REVIEW COMMENTS

FILE #SPR-95-186

TITLE HEADING: Site Plan Review - College Place
Townhomes, Filing #4

LOCATION: 2150 College Place

SITE & LANDSCAPE PLAN

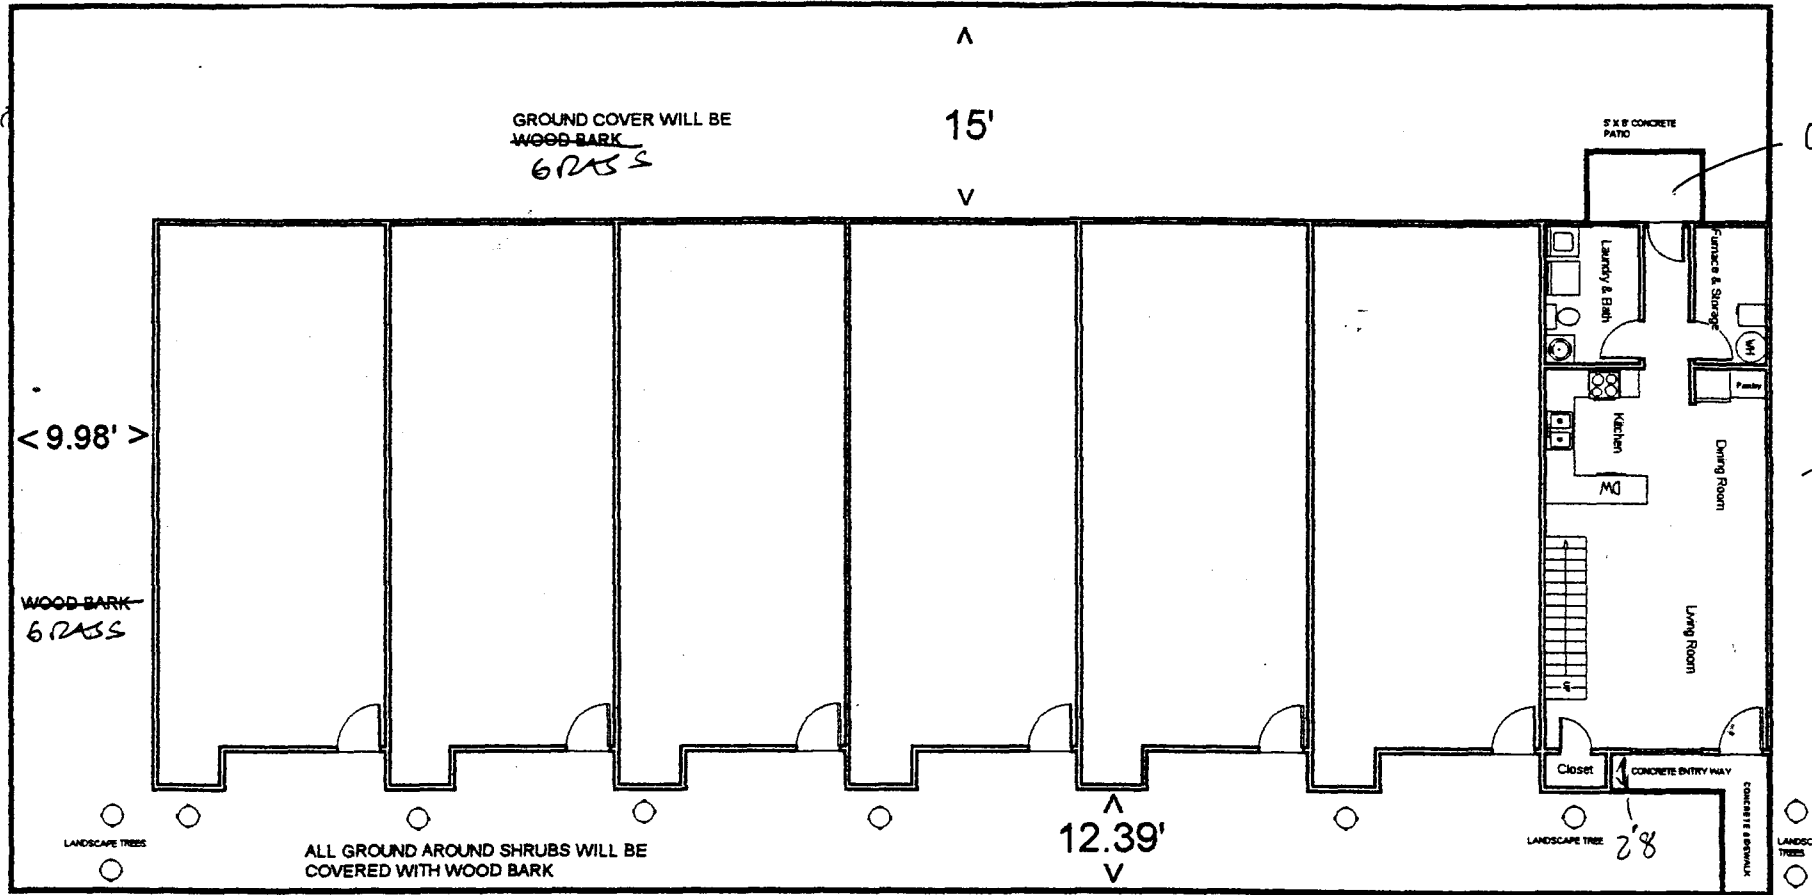
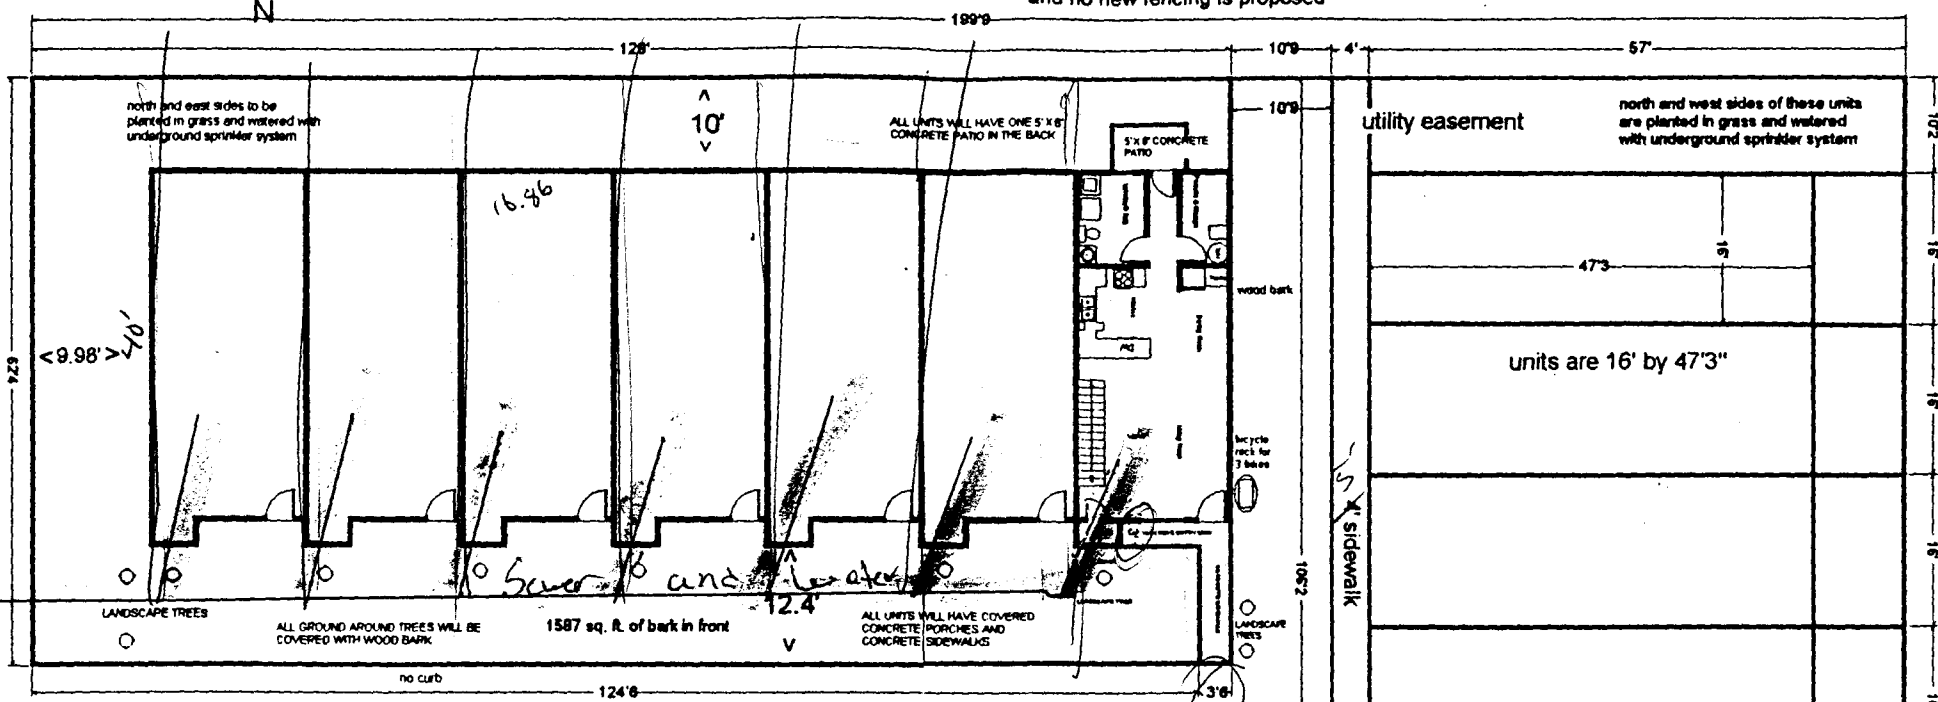
HERE IS PRIVATE OR SPACE AS SHOWN ON PLOT TO SOUTH?

SHOW WALKWAY/ACCESS TO W/O. REAR OF OTHER UNITS

WILL TREES: SHRUBS BE REMOVED?
COVERED? SHOW EXISTING: WORK WILL BE REMOVED

WHAT IS THIS? MORE? DISTANCE TO OTHER UNITS → EXISTING?

Handwritten note: "in the center?"
